Combined License Application Review FERMI 3

Safety Panel 1

February 4, 2015

Staff Confirmatory Analysis

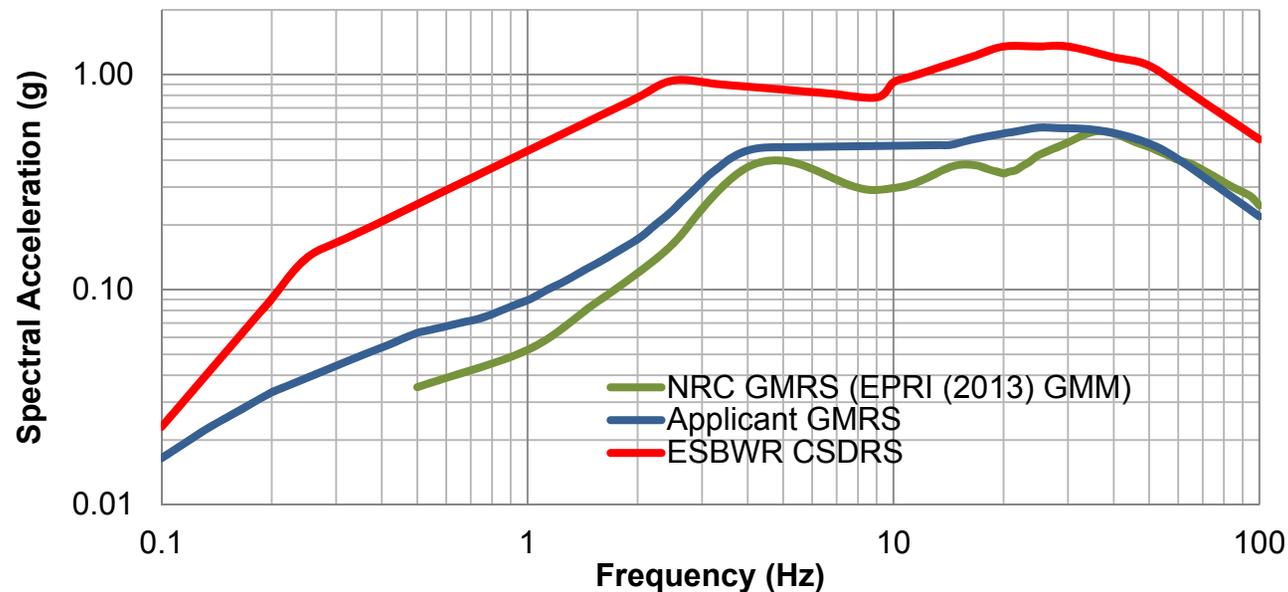
- **Staff's confirmatory PSHA and site response results are similar to the applicant's results**

- **Applicant's GMRS and Staff's GMRS are enveloped by the ESBWR certified seismic design response spectrum (CSDRS)**

Margin in Seismic Input

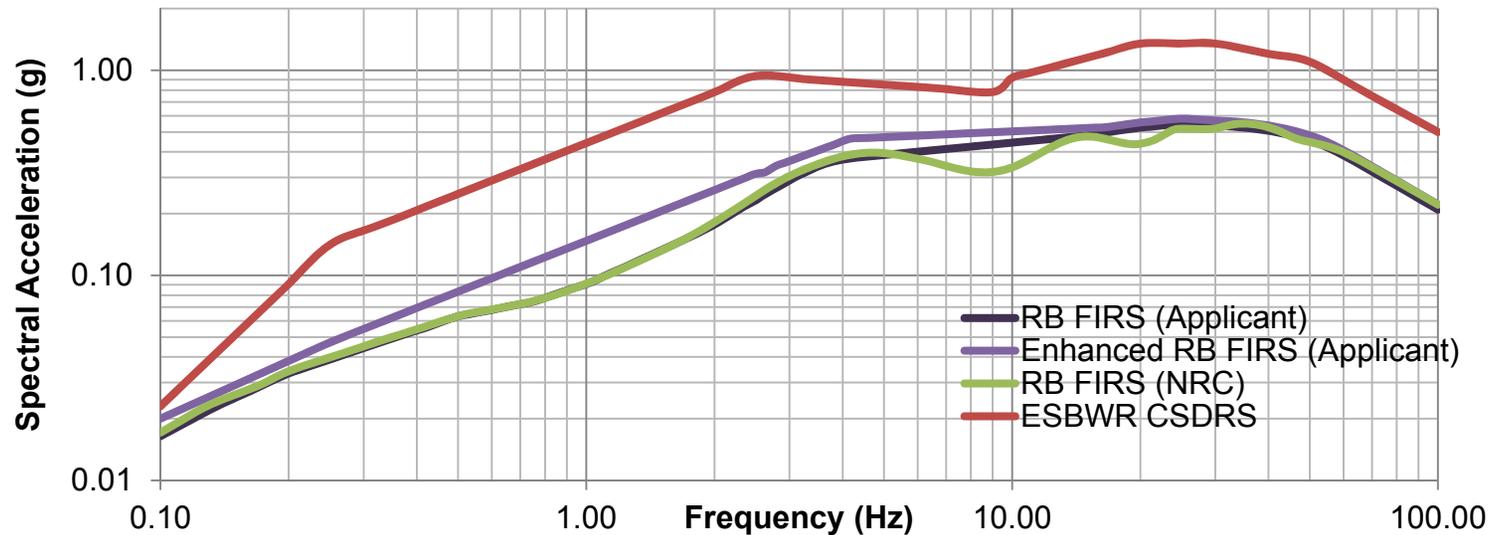
- **ESBWR CSDRS envelops Fermi Reactor Building (RB) site-specific Foundation Input Response Spectra (FIRS)**
